VALUE ENGINEERING STUDY

SELA Flood Control, Orleans Outfalls East Bank of Orleans Parrish, Louisiana

Final Report

DOD SERVICE: Army
VALUE ENGINEERING OFFICER: Frank Vicidomina
VE CONTROL NO.: CEMVN-VE-01-06

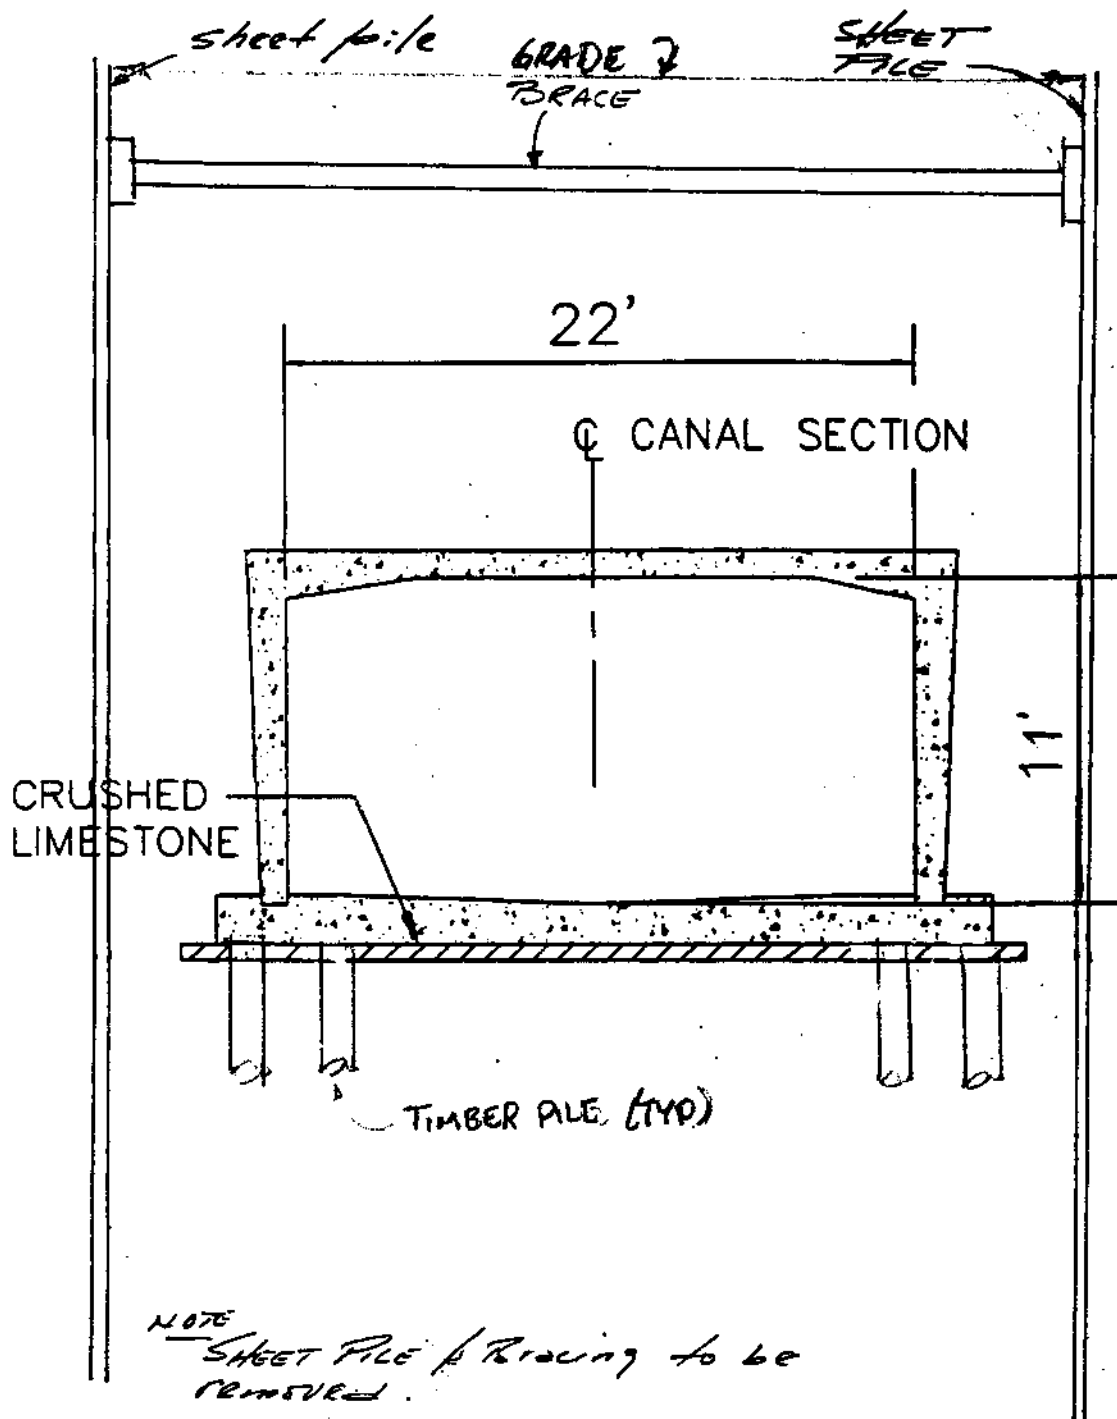
DESCRIPTION: Replace Orleans Avenue cast-in-place box culvert with arch pipe.

This type of construction is being used to build the Cousin canal in Jefferson Parish per Fritz Fromherz of Bridgetek (504-866-8200)/(504-430-5422) who is the marketing representative for Con-Span for this area. The enclosed Cousin's canal is a 36 ft span by 12.5 ft high. It was an alternative to a cast-in-place four-barrel box culvert. Mr. Fromherz indicated that this type of construction will reduce construction time by at least 25 percent. He also indicated that this type of construction would allow for a larger selection of contractors since they need only to form a base.

This proposal would be even more advantageous if accompanied by a clause in the specifications that provided incentive to the Contractor for early completion.

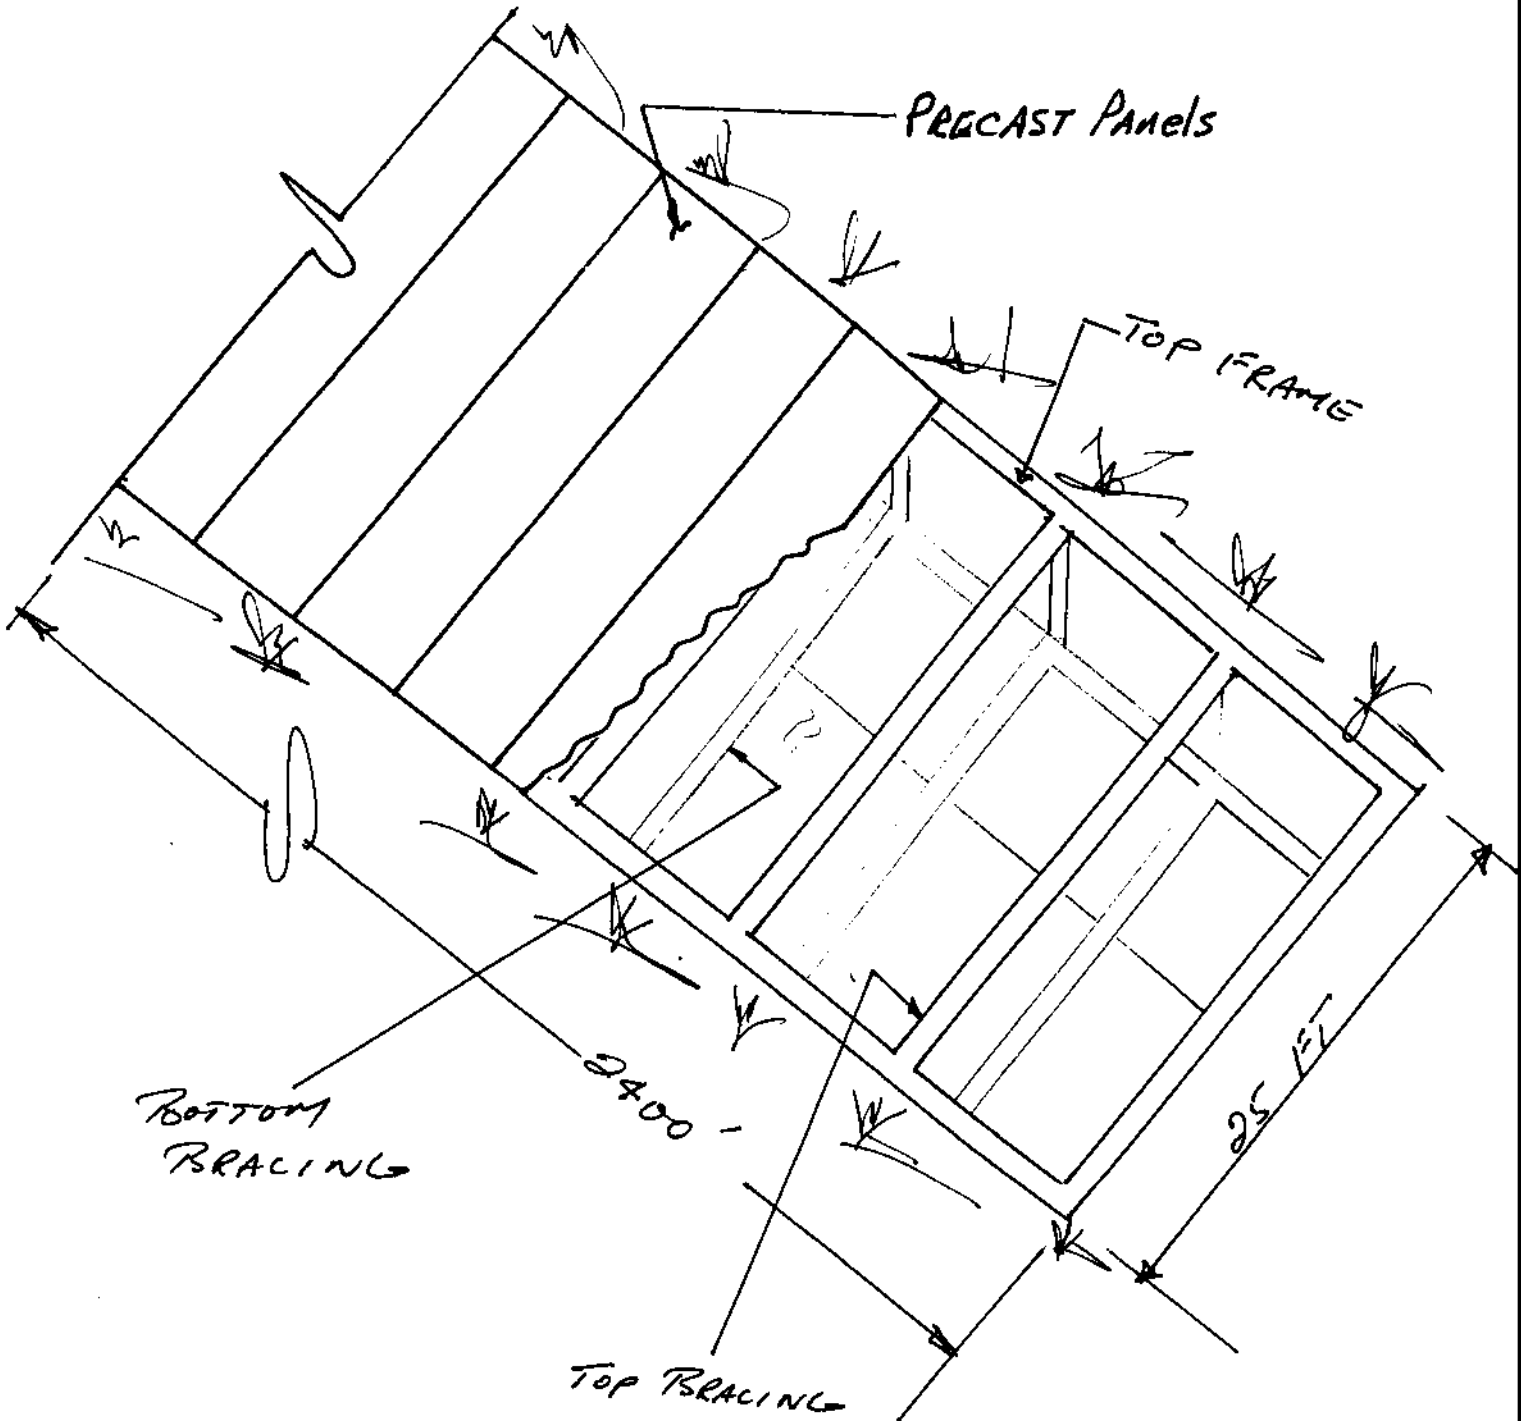
PROPOSED CONCEPT: Provide an alternative means, such as a precast fence; to both prevent water from splashing outside the canal that will also act to prevent anyone from entering the canal.

Precast panels installed across the canal will solve both concerns listed, but create some added issues. Surcharging may damage these panels, inspections are much more difficult as is maintenance. Depending on surcharge conditions, precast structural panels could be washed into the canal and create local flooding by damming the canal.

A 6-foot high precast concrete fence may not completely solve the splashing problem but it should significantly reduce the problem and present a substantial barrier to people who want to climb over the wall. When flow in the canal is large enough to cause severe splashing, conditions are more than likely to be very wet everywhere near the canal and a small amount of splashing outside the canal would not be a major concern. New Orleans is a city concerned with its appearance and an aesthetically pleasing precast concrete fence would improve the attractiveness of the canal more than horizontal precast concrete panels. Also, this approach would be less susceptible to damage from surcharging.

A 'post-less' precast fence can be constructed with gates to enable maintenance/inspection access to the canal.

TYPICAL SECTION THRU PUMPING STATION

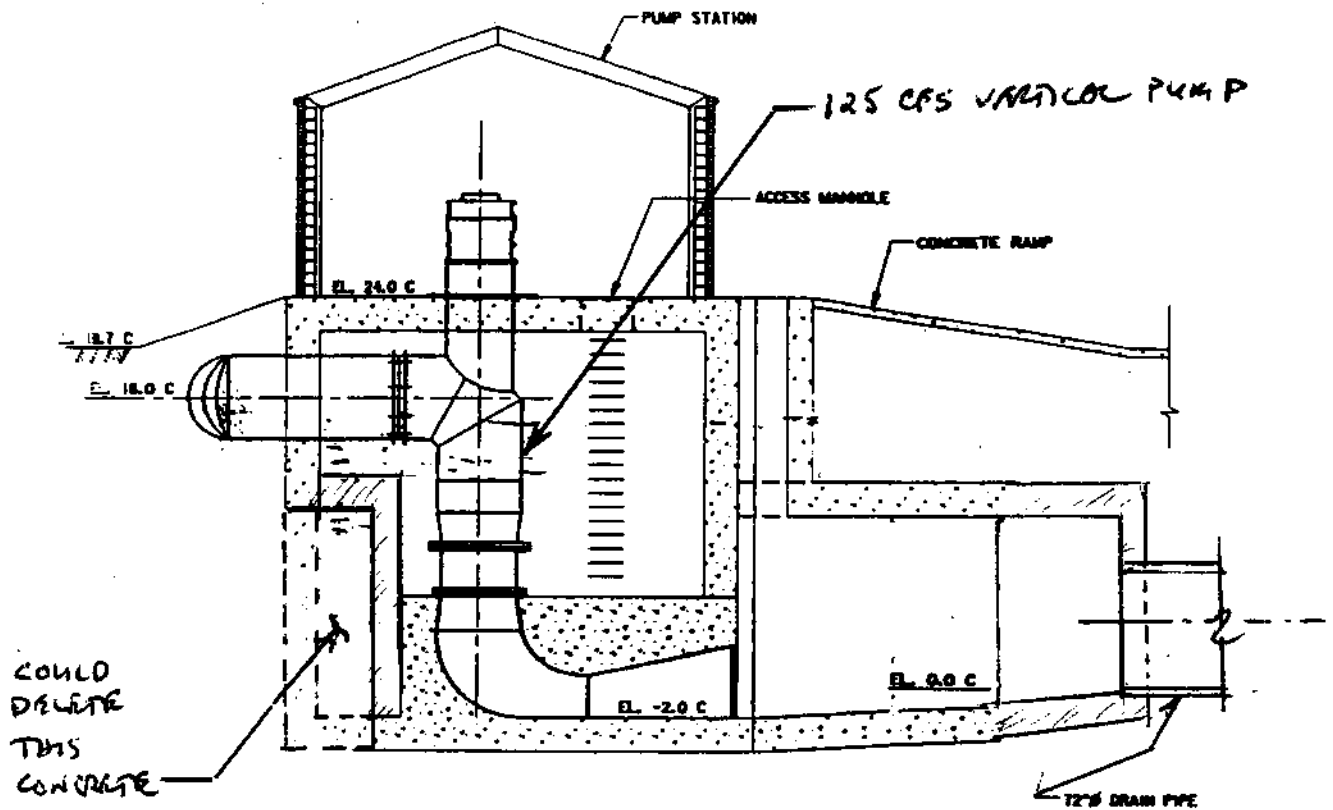
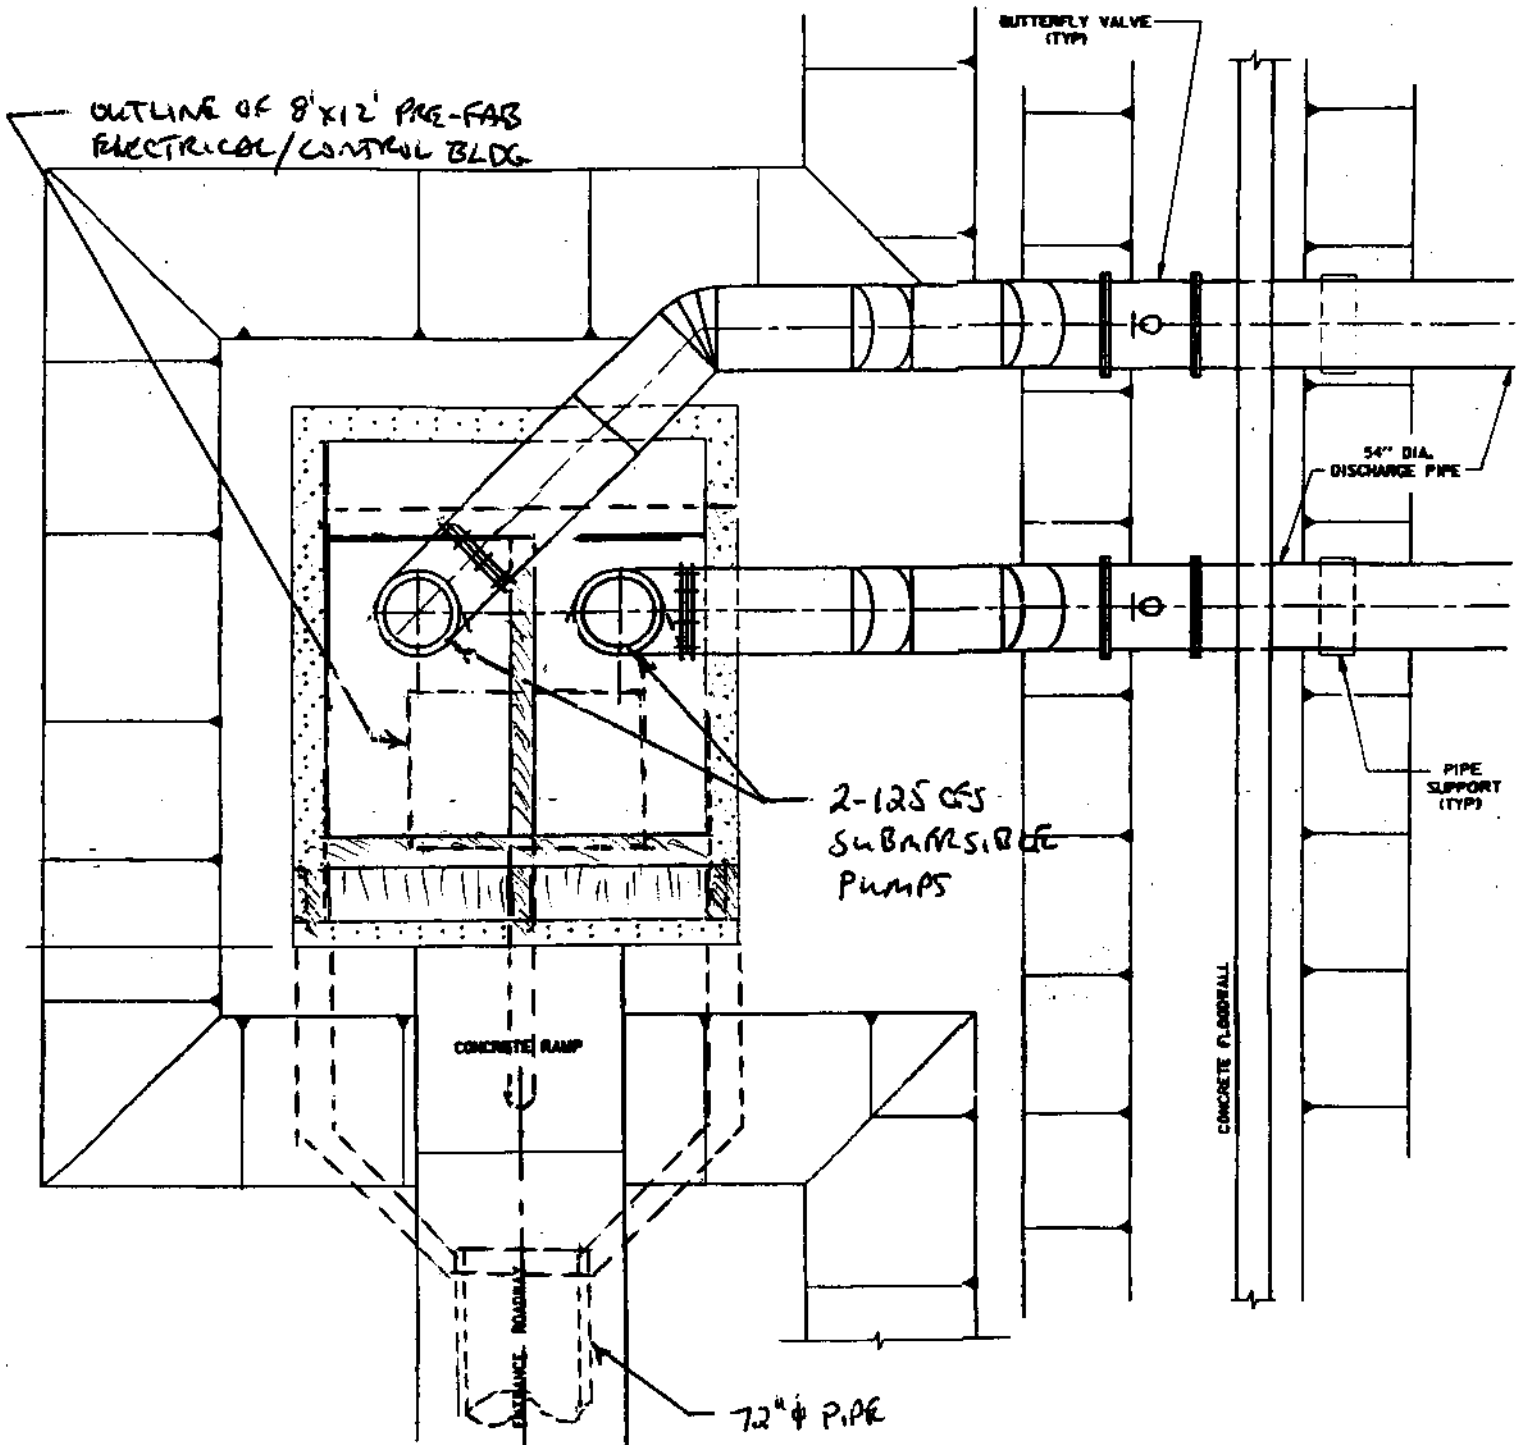
DESCRIPTION: Replace Vertical Pumps with Submersible Pumps

- Local sponsor has strong negative opinions about the O&M of submersible pumps.
- Will require a small housing unit for electrical/control equipment because superstructure has been deleted.
- Pump and motor must be generally removed for maintenance.
- The plan dimension of the pump station may be larger to allow for a properly designed wetwell. This increase in the plan dimension would increase the excavation, backfill, and the substructure concrete quantities.

A small prefab electrical housing unit will be required for the proposed concept. The cost for this item will be equivalent in cost to the control room that is proposed for the original concept.

The proposed concept does not require a superstructure and the cost for this item can be deleted from the proposed concept.

PROPOSED CONCEPT — SKETCH

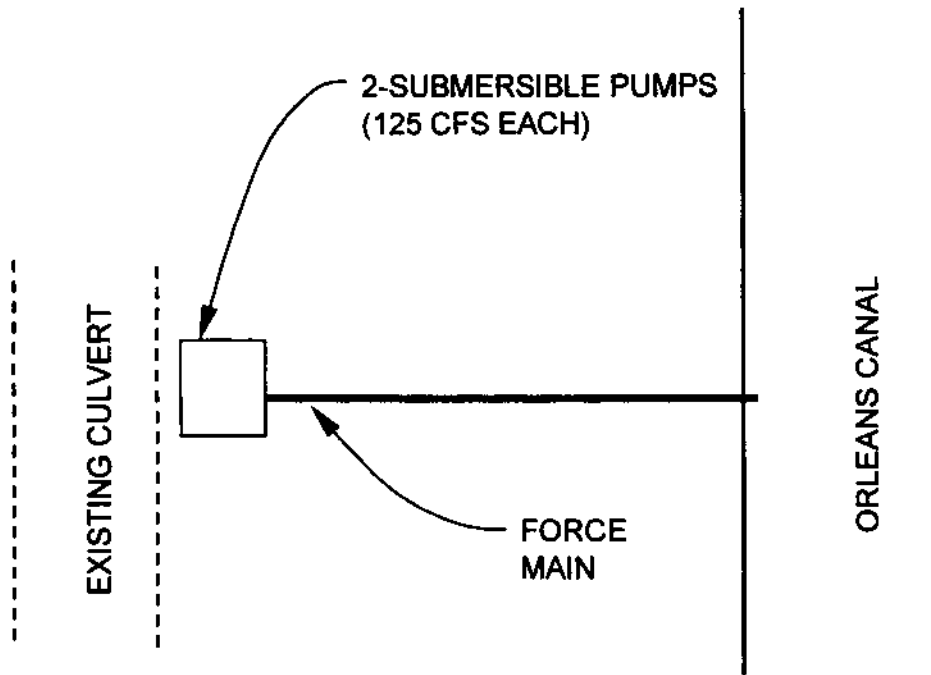
The size of the pipeline to the Robert E. Lee Pump Station is too small for the Original Concept. The pipe should have been approximately a 9-foot diameter pipe instead of the 6-foot diameter pipe. The costs for the 9-foot diameter pipe were determined by the ratio of the cost of the 6-foot diameter pipe to the 9-foot diameter pipe. The backfill and excavation quantities were determined similarly. It should also be noted that the 6 ft diameter pipe for the gravity flow original is slightly undersized and the correct size is closer to 6.5 feet in diameter. However, for purposes of this preliminary evaluation, using a 6-foot diameter pipe is sufficiently accurate.

Revised Pipe Costs = 486,450 x 1.5 = \$729,675 (Approximate increase of \$250,000)

| ITEM | COSTS |
|--|------------------|
| Added cost for 9' diam pipe | <u>\$300,000</u> |

PROPOSED CONCEPT — SKETCH

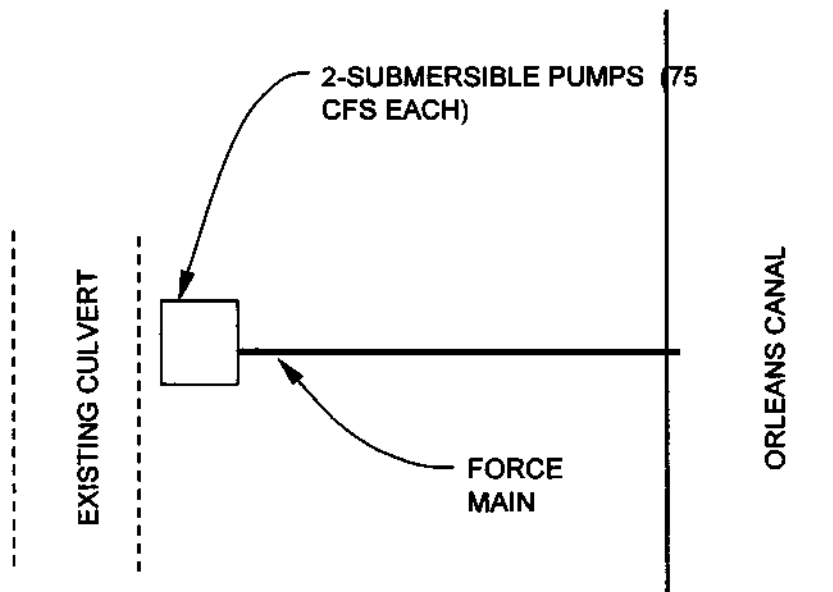
Ratio of 7.0 ft to 6.0ft = 7/6 = approx. 15 % (Say 7.5% to account for constant costs such as sheet pile.)

This is approximately 7.5% (divide 15% by 2 to account for constant costs such as sheet piling), or 92.5% of the original pipeline cost for a 6 ft diameter pipeline. Thus, the 5 ft diameter pipeline cost is

PROPOSAL NO.: RPS-8; HPS-1

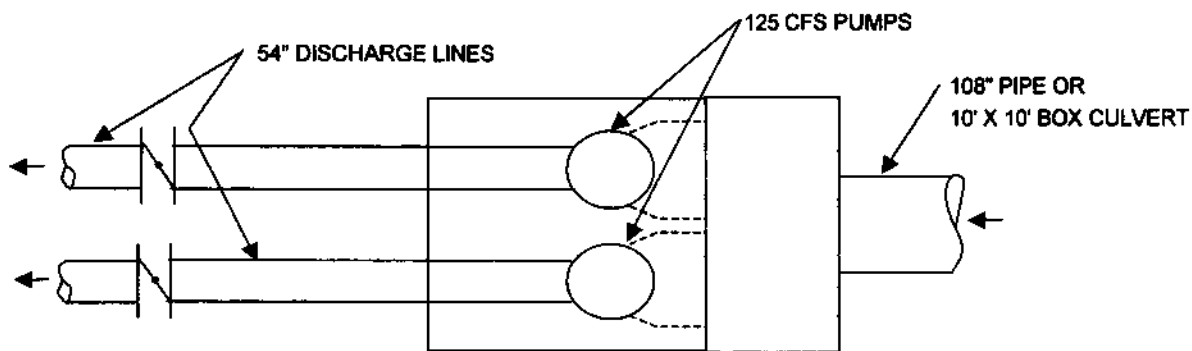
Discussions with the USACE New Orleans District Design Staff indicates that the larger sized stations may not be more effective than a reduced size due inflow constraints.

ORIGINAL CONCEPT — SKETCH

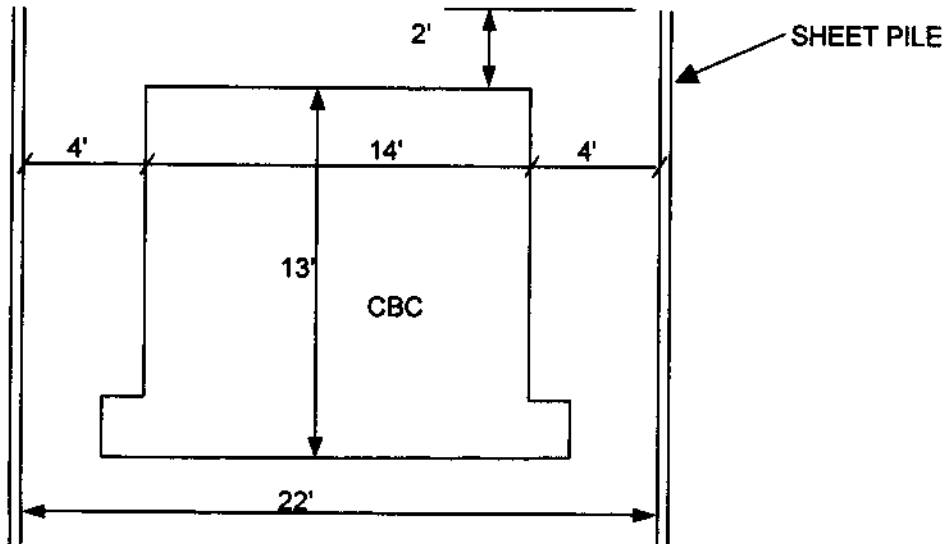
DESCRIPTION: Replace box culvert near Harrison Pumping Station (HPS) with pipe

This alternative was developed considering two 9-foot diameter HDPE parallel pipelines in a common trench. Sufficient compaction of backfill is necessary for this alternative to be feasible. Although the lighter weight pipe will require additional anchorage, it will also settle less than a concrete box culvert.

$$7,000 - ((14 \times 13 \times 550) / 27) = 3292.593$$
